CHIRMORIE WIND FARM

Application For Variation under Section 36C of the Electricity Act 1989

Chirmorie Wind Farm Ltd

June 2019

Figure 3.1: Site Layout Plan

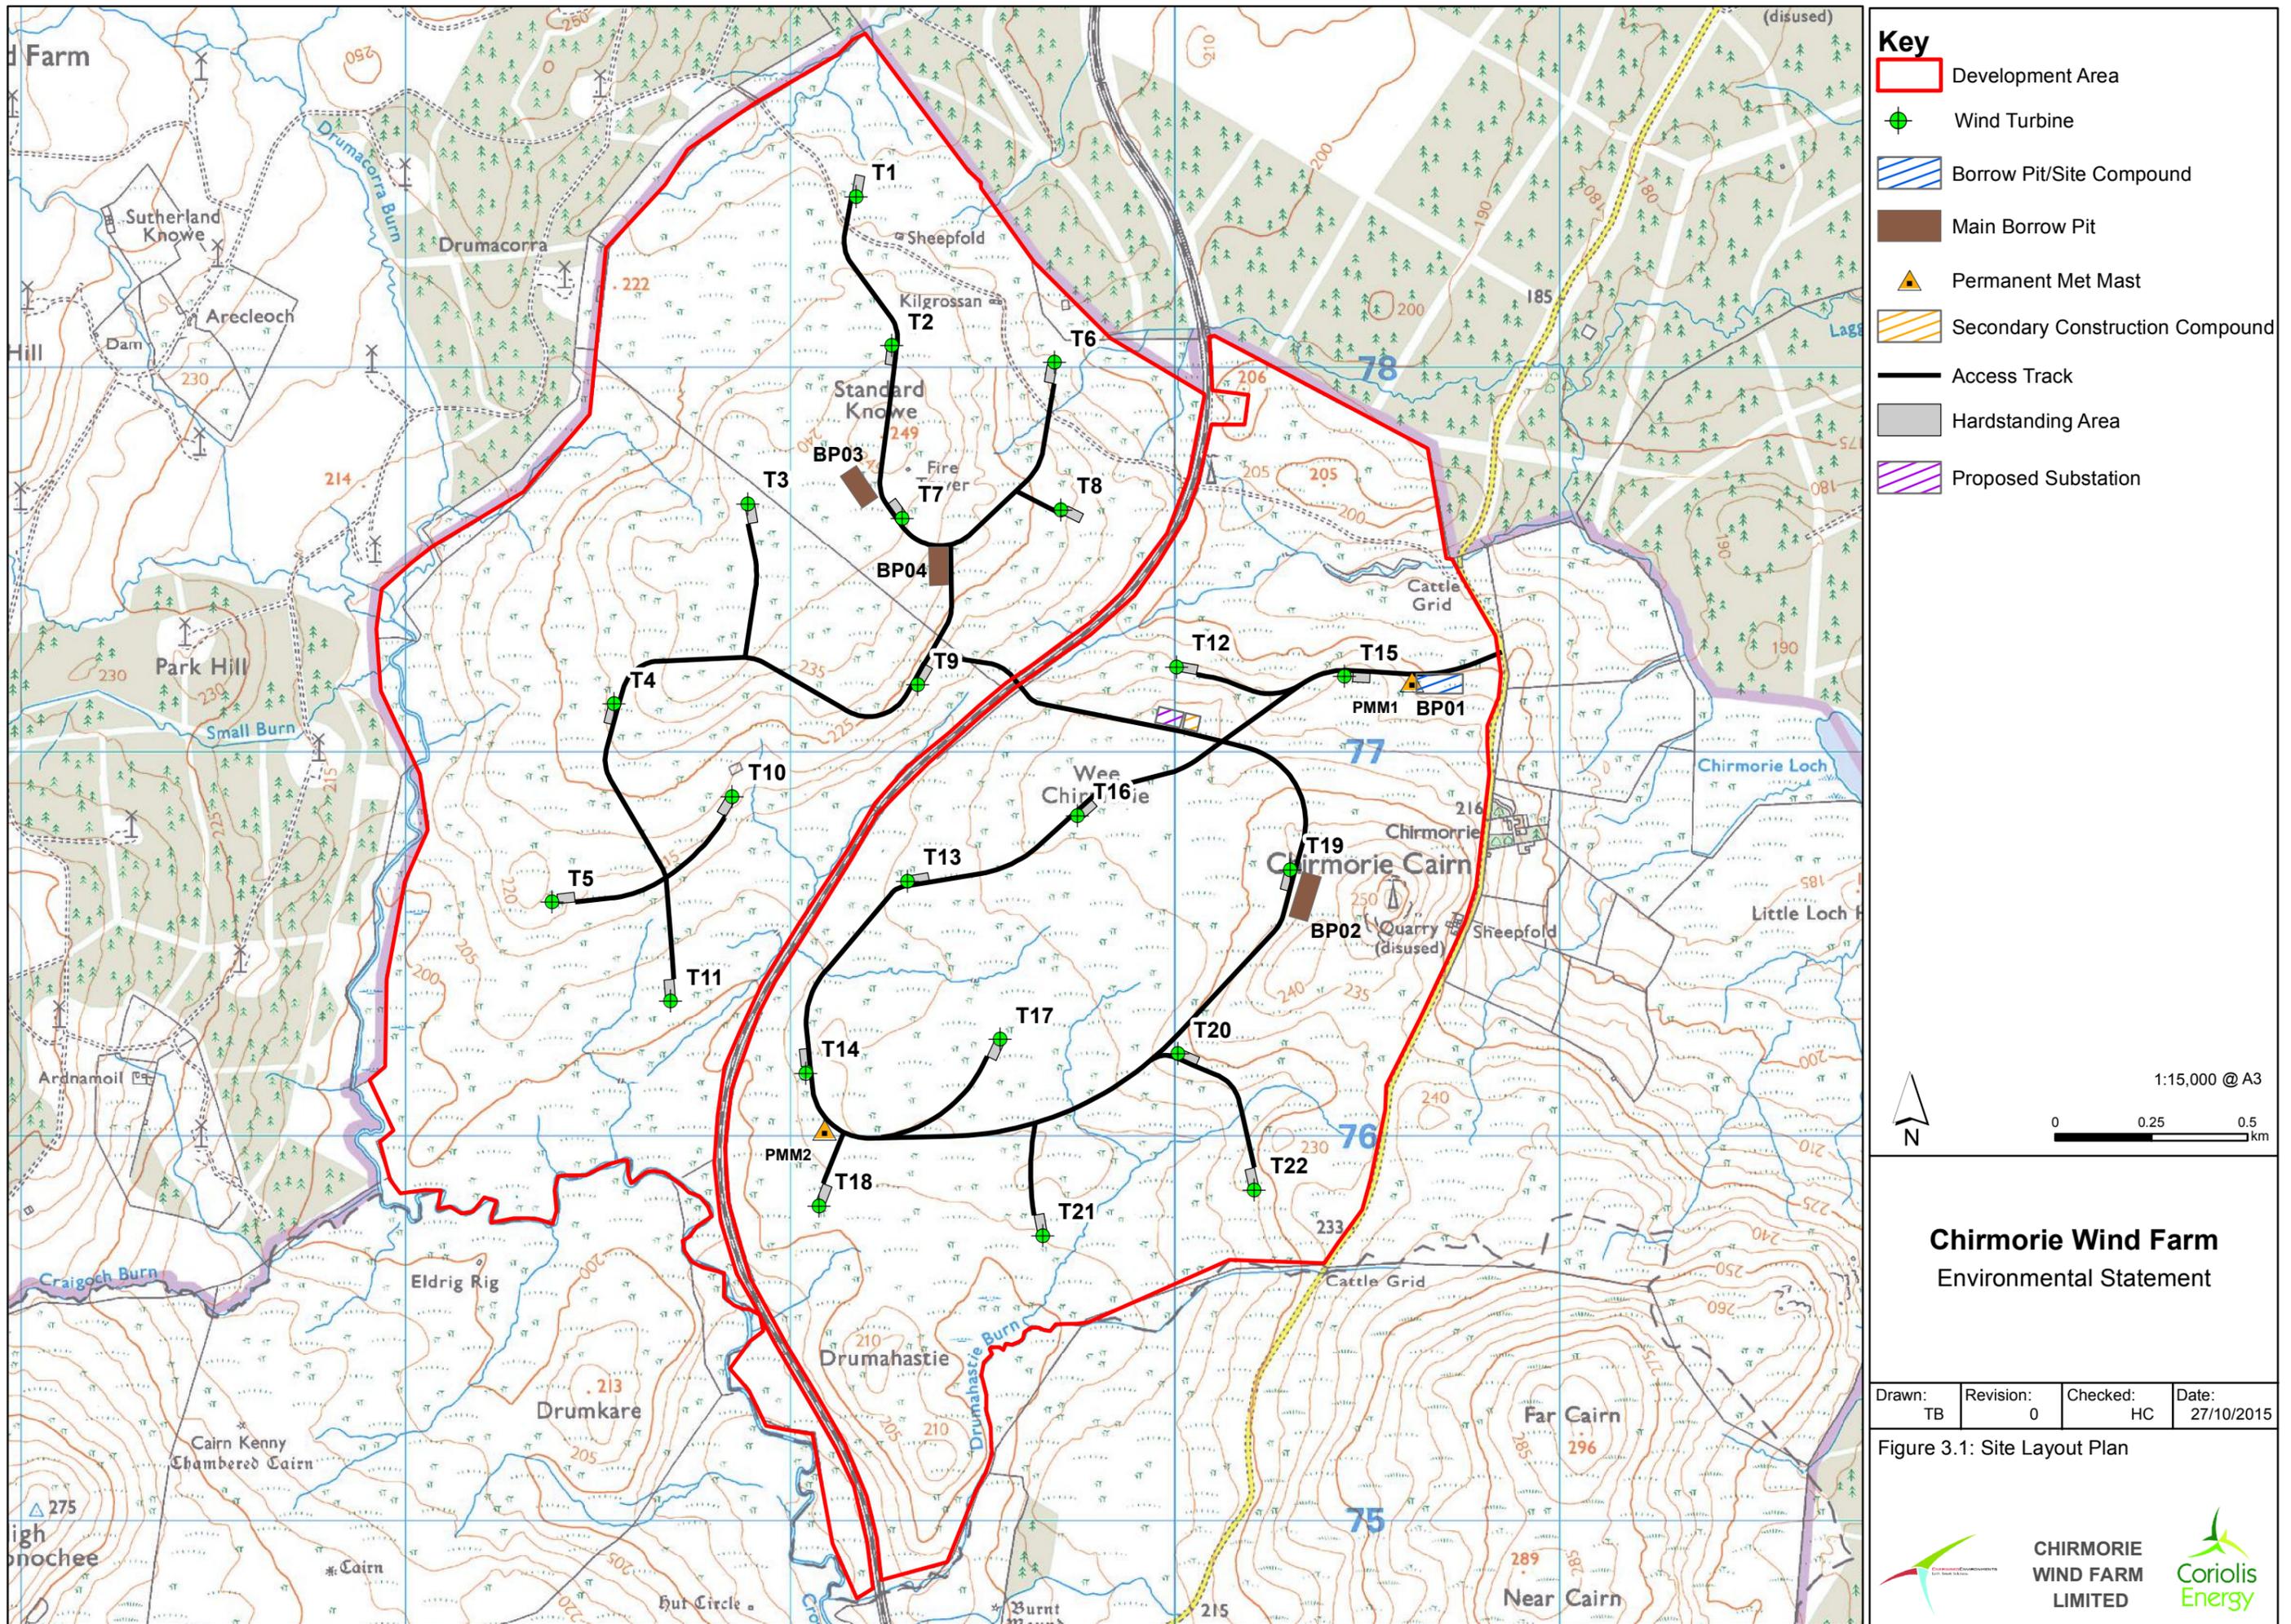
~~a.~~ the approved drawing figure 3.1A and 3.1B site layout map and access route map (amended post application to remove WTG22) which are included in Appendix 4 of the section 36C variation application dated x May 2019~~at Annex 5 to this decision notice~~

Project Number	R1700002445	Figure No.	V3.1
Date	May 2019	Prepared By	AG
Scale	1:32,000 @ A3	Issue	1
Client	Chirmorie Wind Farm Limited

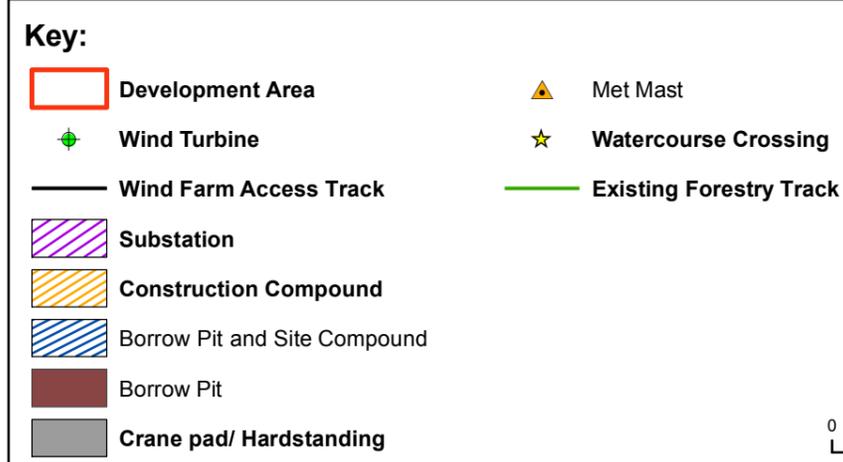
- Condition 5 - Implementation in accordance with approved plans and requirements of the permission – a new drawing (Figure V3.1) will replace original Environmental Statement (ES) Figure 3.1, excluding Turbine no. 22 and will also show the location of the new access route and proposed new borrow pit. It is anticipated that the Screening Report (submitted to Scottish Ministers in March 2019 – see below) will also form part of the approved documentation.
- Condition 33 – Site Decommissioning, Restoration and Aftercare – the condition will be updated to refer to decommissioning occurring no later than the date falling thirty years from the date of Final Commissioning to take into account the extended life time of the wind farm.

The revised Figure V3.1 (Proposed Varied Development) is included in Appendix 4 to vary this consent.

In terms of infrastructure changes, other than the relocation and scale of the substation, and the inclusion of a new access track from the main road (A714) to the wind farm access on the unclassified road (the C72), there are no changes proposed to the location or scale of the 21 turbines or the internal access tracks already consented.

The size of the substation will need to be increased to allow for more space to incorporate the wind farm electrical connection. At the time of the original S36 application the applicant scaled the substation based on the connection requirements known at the time, however since then it has come to light that more space is required to allow Chirmorie Wind Farm and Scottish Power Energy Networks to construct their own separate infrastructure within the same area. A plan of this is shown on Fig V3.1.
